Our Ref: AJC/21592 v2

22 December 2021

**HGY/2021/2304 – 29-33 The Hale, London N17 9JZ**  
**Independent review of Applicant's daylight and sunlight assessments**

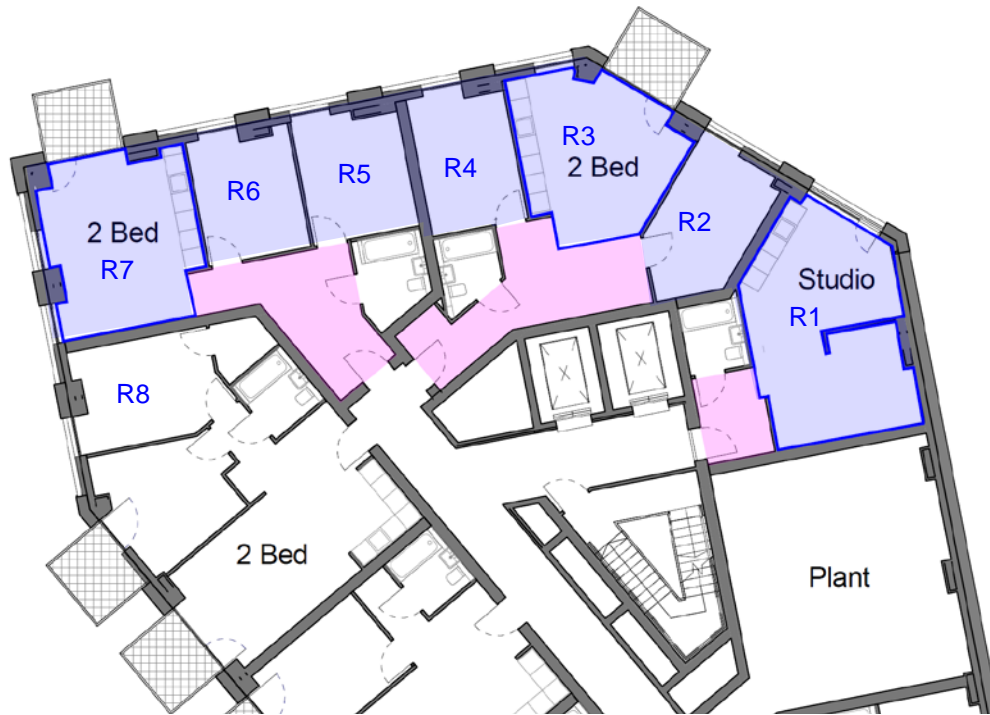
The floor plans for North Island Building No. 3, which I obtained from planning application reference HGY/2018/2223, show 8 dwellings per floor on a typical floor. Point 2 have assessed the habitable rooms in three dwellings per floor that take light from over the site (labelled R1 to R7 in the plan extract at [Figure 1](#) below), plus a vertical stack of west-facing bedrooms (labelled R8) serving a fourth flat per floor, which will be unaffected and can be ignored.

The floor plan extract in **Figure 1** above shows the internal layout of a typical floor. The key rooms, anti-clockwise from east to west, are:

- a studio or LKD (R1) of a studio or 1-bed flat
- a bedroom (R2), LKD (R3) and further bedroom (R4) of a 2-bed flat on the splayed corner
- two bedrooms (R5 and R6) and LKD (R7) of a two-bed corner flat

**Figure 2** Annotated 3D view of Building 3 showing how the room uses stack vertically facing the Site

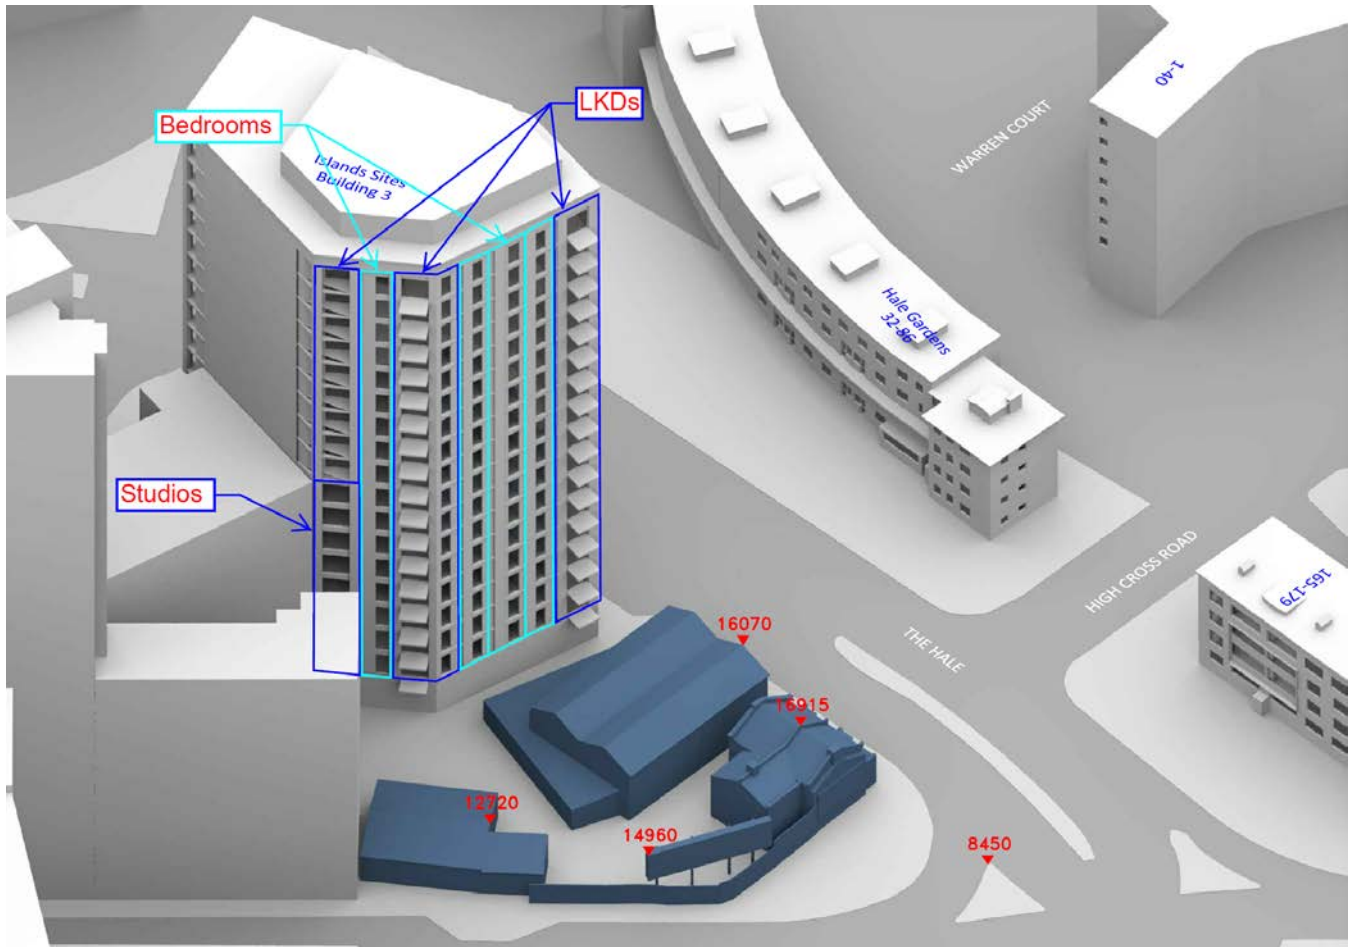
In **Figure 2** below I have marked up a 3D view of Point 2's computer model to show how the room uses stack vertically. It should be remembered that bedrooms have a lower requirement for daylight.

The May 2021 scheme would cause adverse daylight impacts to all but 11 of the 136 site-facing windows from first to 17<sup>th</sup> floor levels, with high-magnitude VSC impacts to 109 windows, medium-magnitude impacts to 6 windows, and low-magnitude impacts to 10 windows, as well as high-magnitude NSL impacts to 66 rooms, and medium-magnitude impacts to 2 rooms (see [Tables 2 and 3](#) above). A further 34 windows serving the corner LKD (R7) on the west elevation are unaffected, as they face away from the Site.

The relative loss of VSC to the site-facing windows that are not directly overhung by balconies ranges from:

- 73% to 91% at first floor level;
- 40% to 79% at sixth floor level;
- 5% to 77% at eleventh floor level; and
- 5% to 70% at sixteenth floor level.

The affected rooms are LKDs, bedrooms, and studios. The significance of daylight effects to the site-facing apartments would be **major adverse**.

**Figure 3** May 2021 scheme (left) and November 2021 amended scheme (right) in which the tower has been set back by 3m, away from Building 3

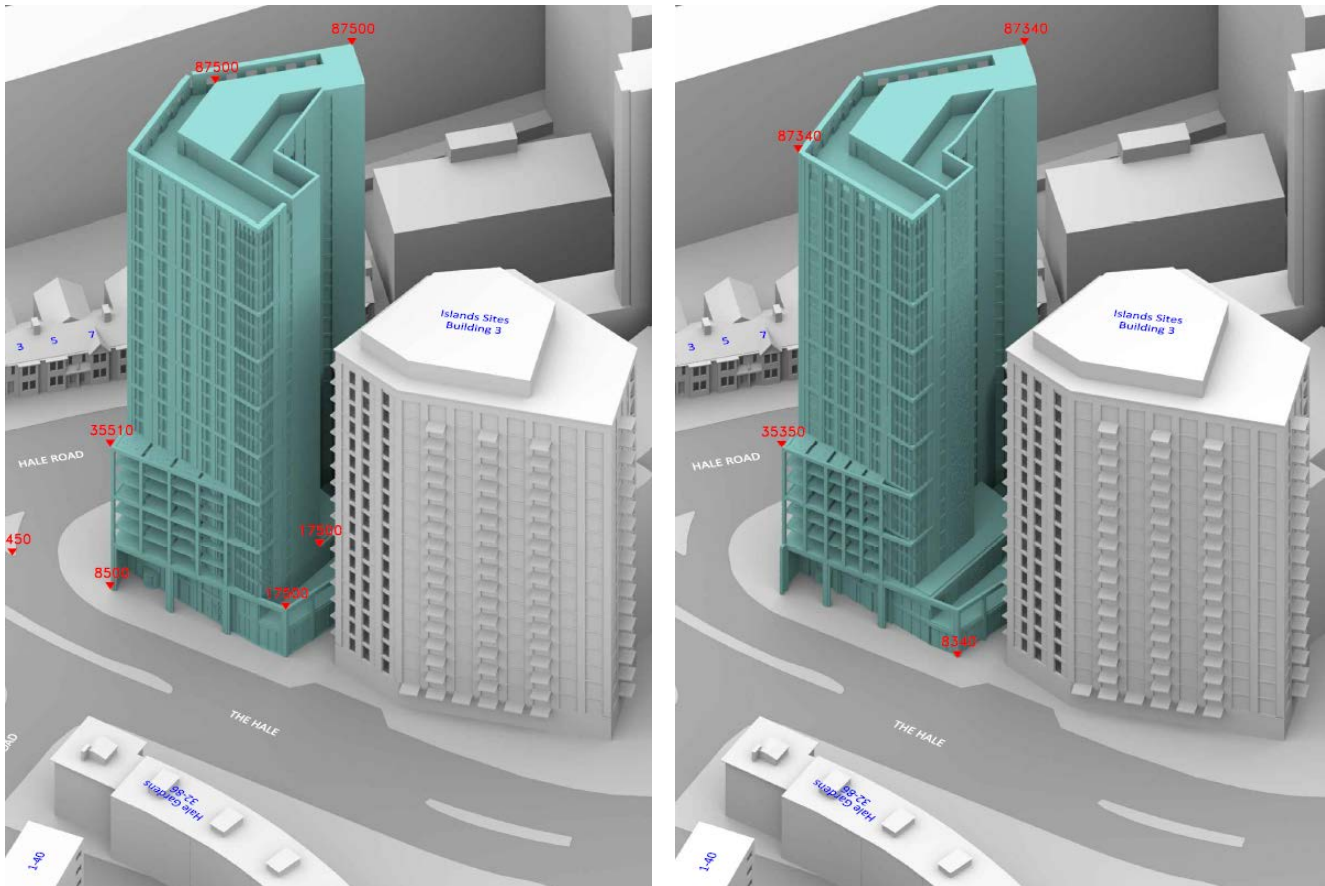
The Applicant has subsequently amended the scheme by setting back the tower element by three metres, so that it is now 13 metres from Building 3. The difference can be seen in [Figure 3](#) below, which shows extracts from the rendered images of Point 2's 3D computer models. The May 2021 scheme is on the left and the November 2021 amended scheme is on the right.

Point 2 re-ran the VSC impact assessment for the revised scheme, but not the NSL assessment. The VSC results show that the revised scheme would result in high-magnitude VSC impacts to 107 windows, medium-magnitude impacts to 8 windows, and low-magnitude impacts to 10 windows. So, two windows have downgraded from high impact to medium impact. Furthermore, the magnitude of some of the impacts have reduced slightly. The relative loss of VSC to windows that are not directly overhung by balconies now ranges from:

- 72% to 87% at first floor level (lessened slightly from 73% to 91%);
- 37% to 72% at sixth floor level (lessened slightly from 40% to 79%);
- 5% to 69% at eleventh floor level (lessened slightly from 5% to 77%); and
- 5% to 61% at sixteenth floor level (lessened slightly from 5% to 70%).

The amendment will therefore lessen the daylight impacts to a small degree, because it would slightly increase the view of sky around the south side and over the top of the development, though the latter will only be of very marginal benefit to the highest floor levels in Building 3. The significance of daylight effects of the November 2021 amended scheme to the site-facing apartments would still be **major adverse**.
